October 3, 2018

SUBJECT: TRC COMMENTS FOR MUTTLEY SQUARE, PL2018-0017

A BINDING SITE PLAN

**GRADING AND DRAINAGE PLAN
AND DETAILS**

Figure I-1. Vicinity map (from Google Maps).

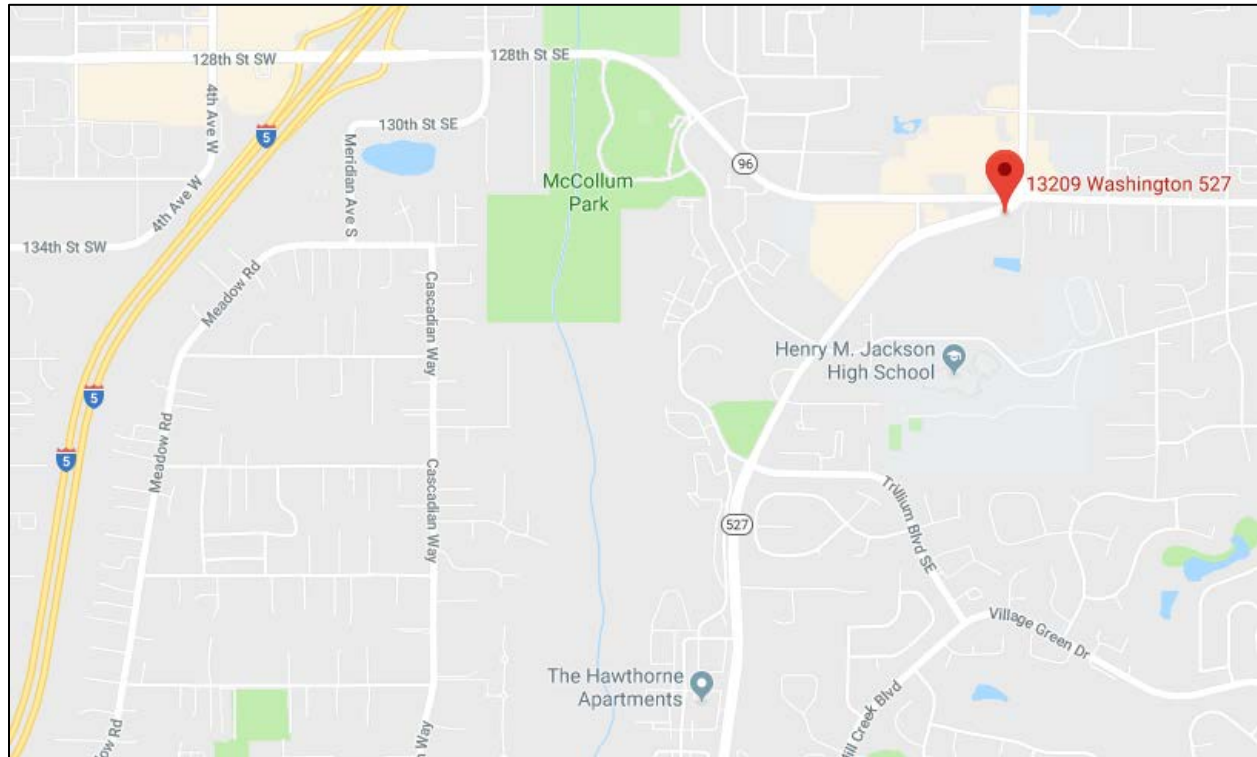
What about runoff from the pervious area, which was previously forested and now appears to be cleared and vegetated with grass. Calcs show that this area is also being collected and conveyed to the detention pipe.

Figure III-1. Study area map.

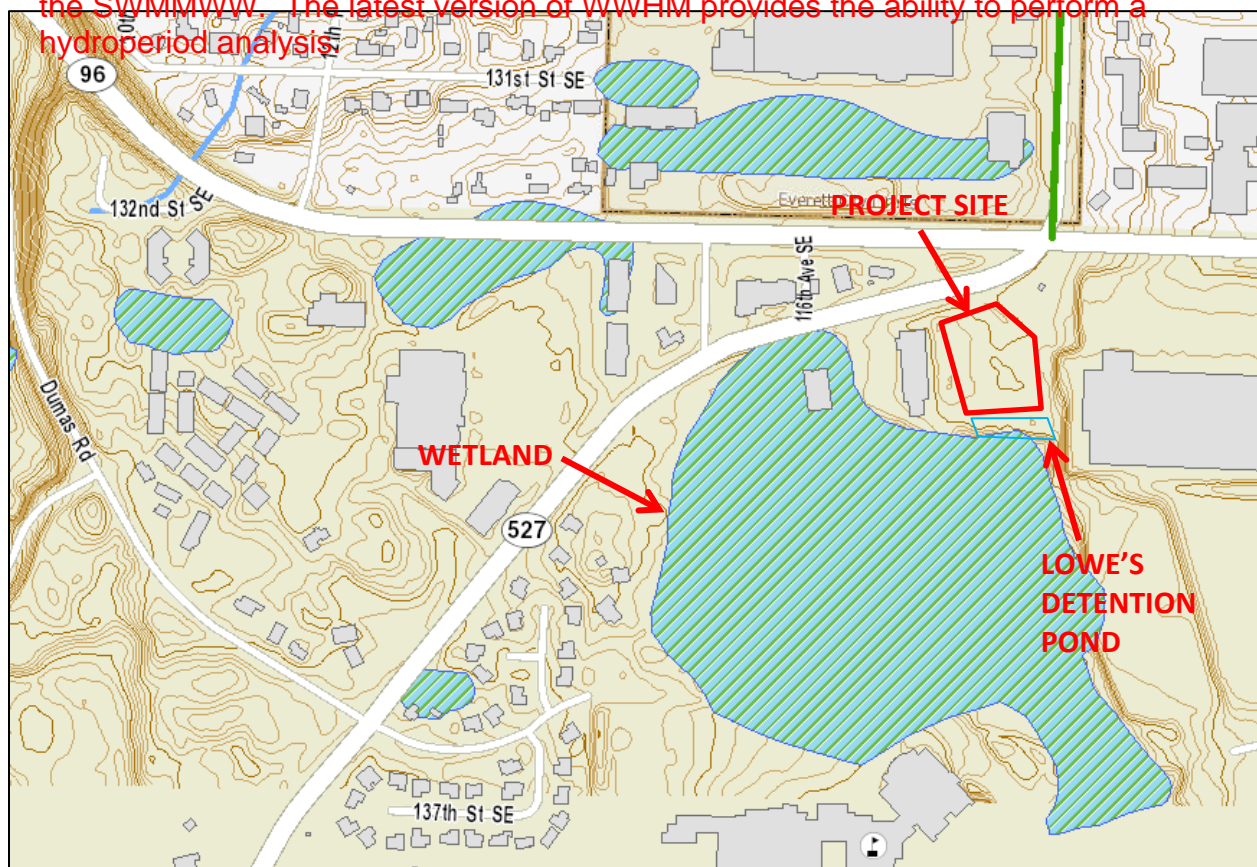
A hydroperiod analysis will need to be conducted in accordance with Guide Sheet 3B in the SWMMWW. The latest version of WWHM provides the ability to perform a hydroperiod analysis.
